UNITED STATES PATENT AND TRADEMARK OFFICE

APPLICATION NO.	FILING DATE	FIRST NAMED INVENTOR	ATTORNEY DOCKET NO.	CONFIRMATION NO.
10/064,605	07/30/2002	Ronald Scott Bunker	124626-1	6850

Office Action Summary	Application No. 10/064,605	Applicant(s) BUNKER, RONALD SCOTT	
	Examiner Raymond Alejandro	Art Unit 1745

DETAILED ACTION

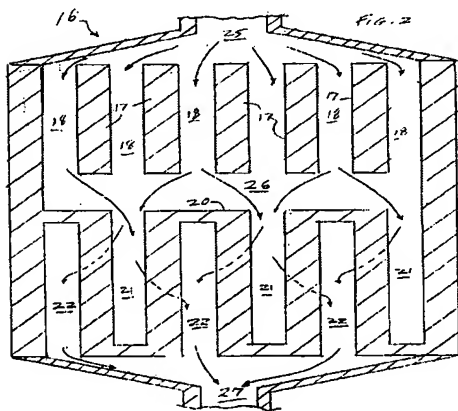
Figure 2 below depict the flow field plate comprising a base plate; and first and second side plate structurally connected to the ends of the base plate. The base plate includes ribs 17 defining flow-through flow field channels 18, and a serpentine rib 20 that defines inlet channels 21 and outlet channels 22 (SECTION 0013). It is also disclosed that the hybrid flow channels may be implemented in a flow field which folded one or more times (SECTION 0006). *Thus, if the channels are folded, the resulting plate structure will have channels laying one over another.*

It is also disclosed that the hybrid flow channels may be implemented in a flow field which folded one or more times (SECTION 0006). *Thus, if the channels are folded, the resulting plate structure will have channels laying one over another.*

Margiott also discloses a plurality of ribs 17 that project from the flow field plate and form recesses or indentations on the plate surface (SECTION 0013/ FIGURE 2). *Therefore, the ribs themselves also act as the claimed concavities.*

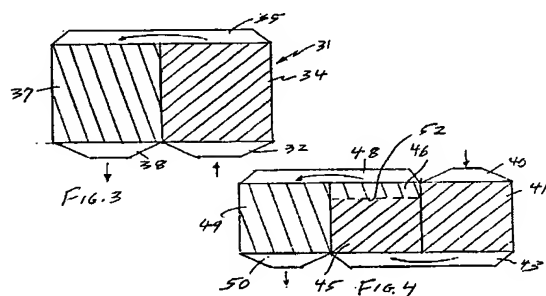
Figures 3-4 below illustrate the flow field plate in a folded configuration in which the oxidant enters through an inlet manifold 32, passes through a portion 34 of the plate having channels, then is turned by a flow reversing manifold 35 so as to flow through a portion 37 of the plate 31 which also has channels (SECTION 0014). In particular, Figure 4 shows the transition between the portions 34 and 37 not at the manifold 35 but mid-way between the manifold 35 and either of the manifolds 32 or 38 (SECTION 0014).

Hence, Margiott's flow field plate comprises a plurality of upper ribs and a plurality of bottom ribs forming top channels and bottom channels in the flow field plate per se to allow a flow of fluid to alternate between the top channels and the bottom channels.

Figures 3-4 above illustrate flow fluid plates in folded configurations wherein the flow reversing manifold or the transition between the plate portions and the flow-through flow field channels and the interdigitated flow field channels are disposed at the angle of substantially 90 degrees to provide the turns or reversing manifolds.
